February 17, 2026

**RE: UTRCA Comments – Acorn Valley Development  
Applications for Draft Plan of Subdivision (39T-TC2501) and Zoning By-law  
Amendment (Z20-25)  
Applicant: Doug Tarry Developments c/o Tracy Tucker  
83 Christie Drive, Dorchester**

## **APPENDIX B: DRAFT PLAN OF SUBDIVISION**

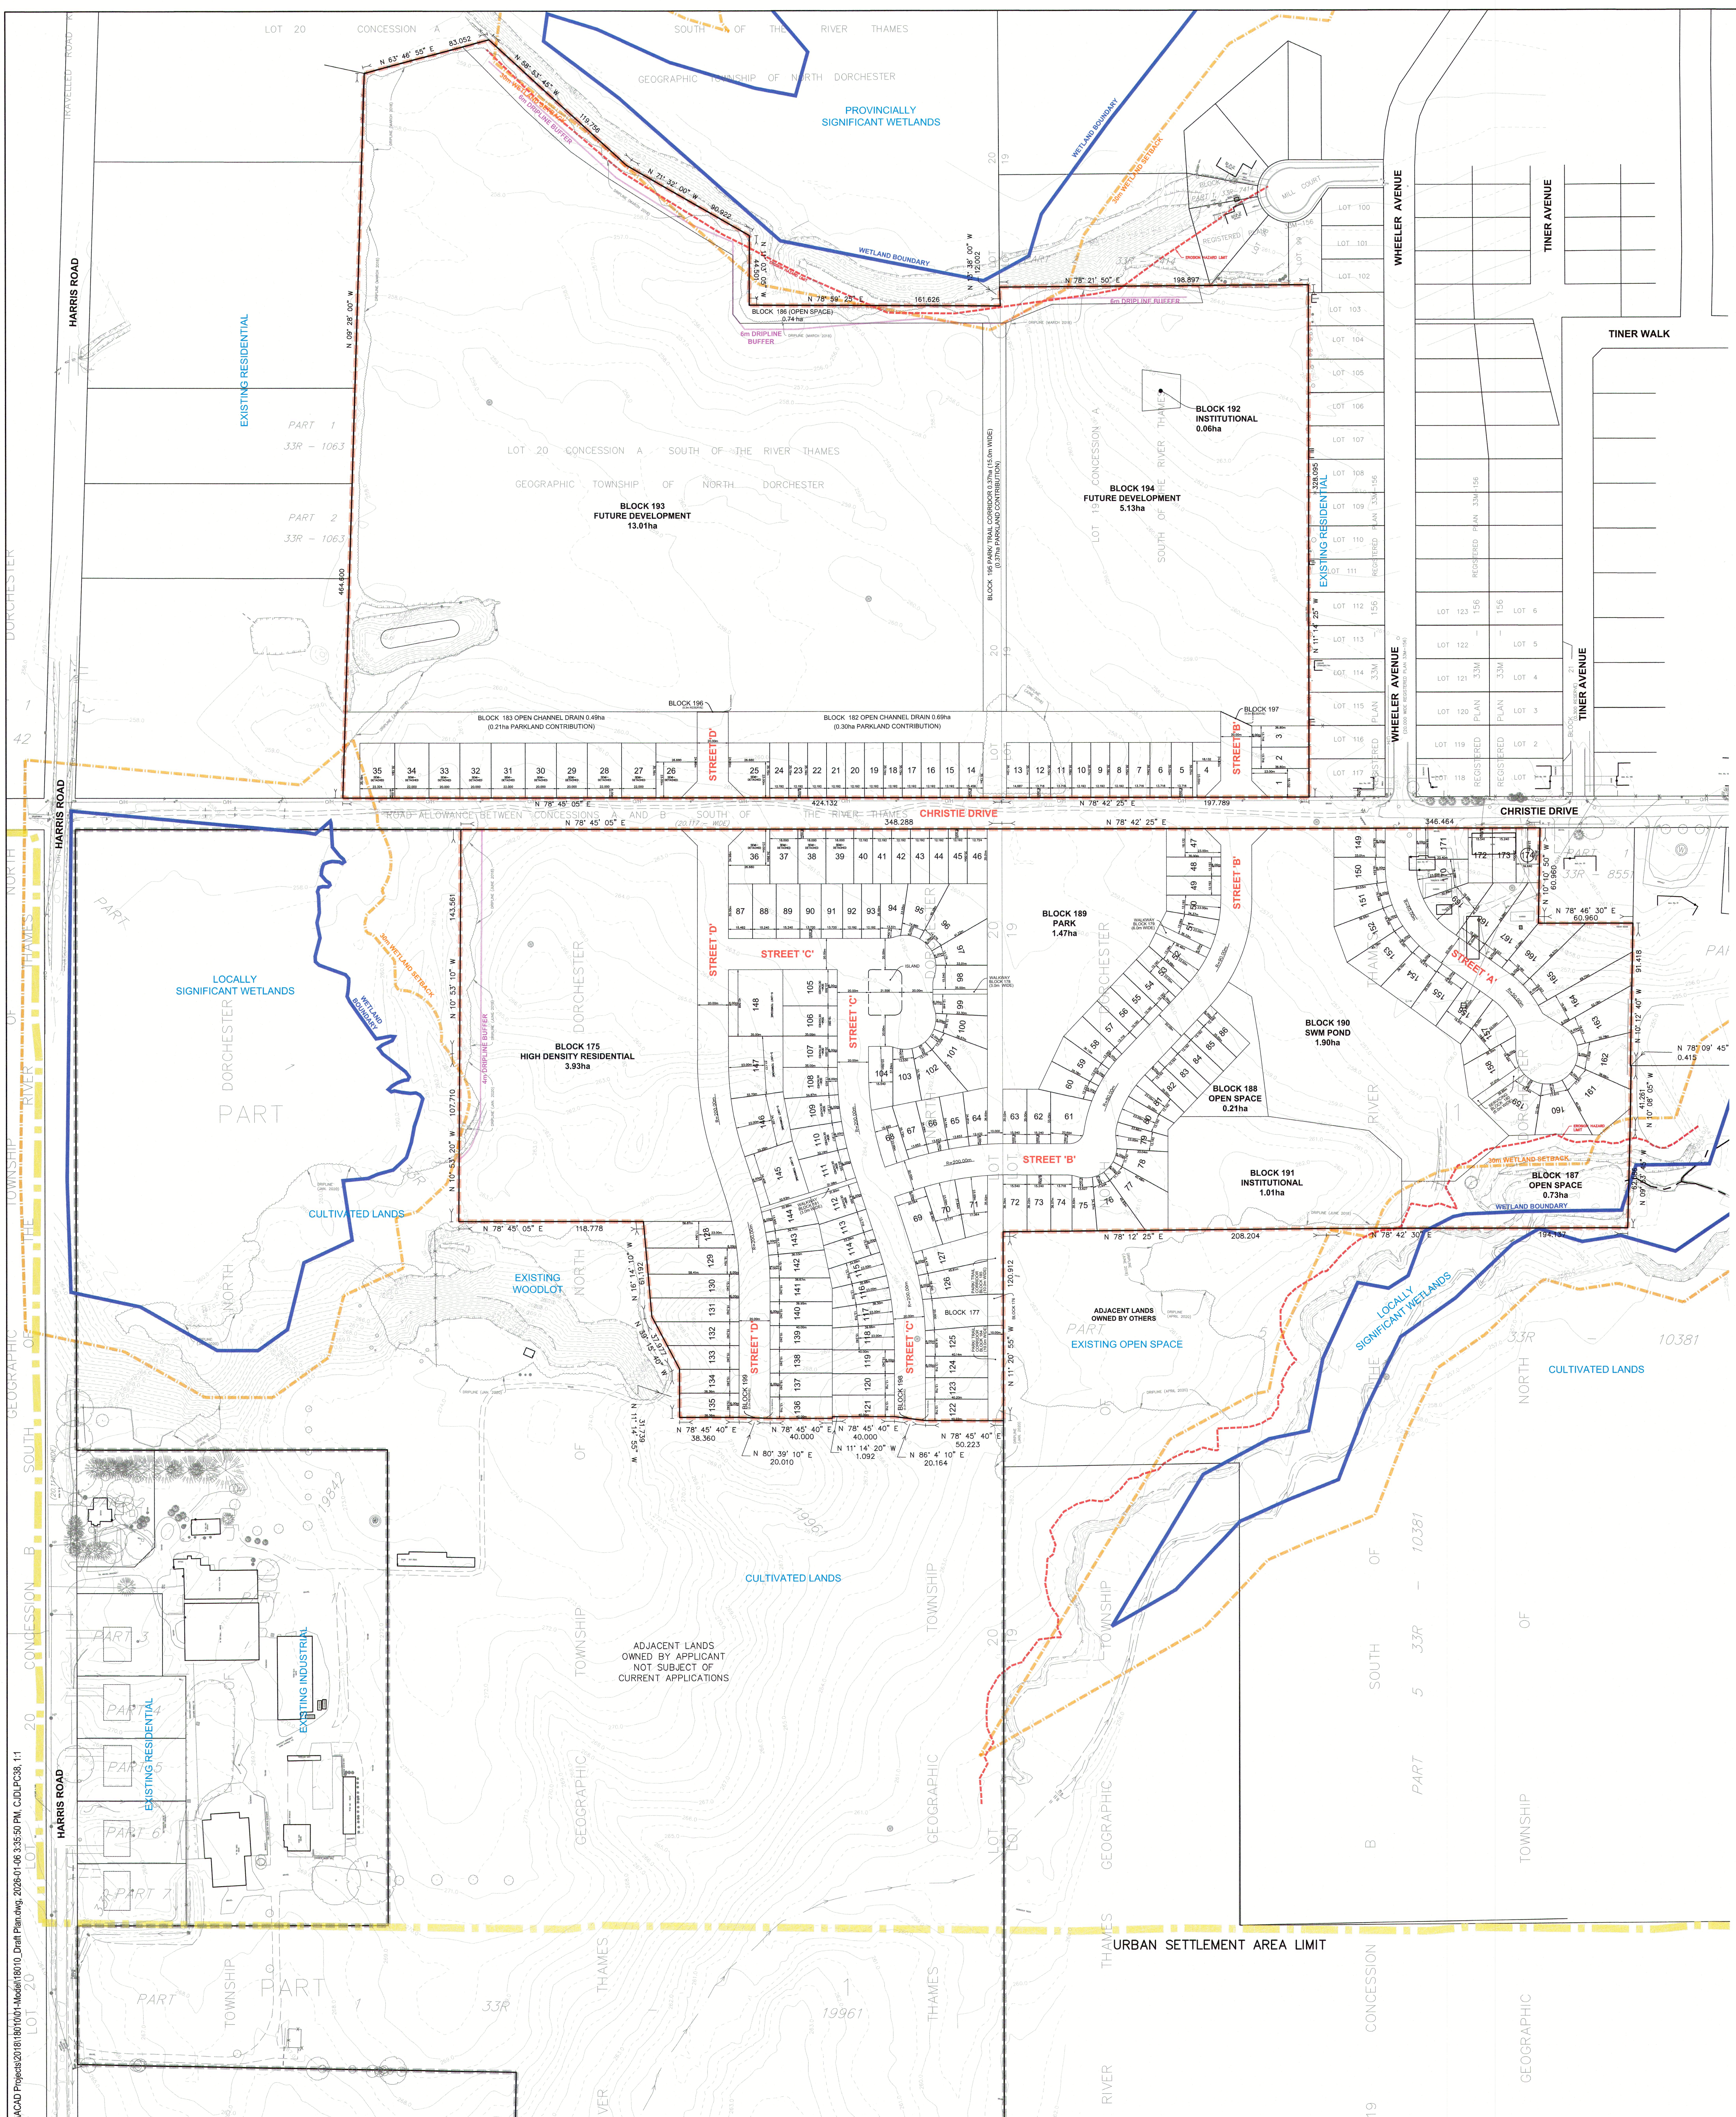
4. Forthcoming. Dry access should be provided to the Future Development Block 193 and Block 194 across the conveyance channel during a regulatory (250-year) storm. At a minimum safe access must be demonstrated. The UTRCA will review access to the Future Development Blocks as part of the engineering submission as a condition of draft plan approval.
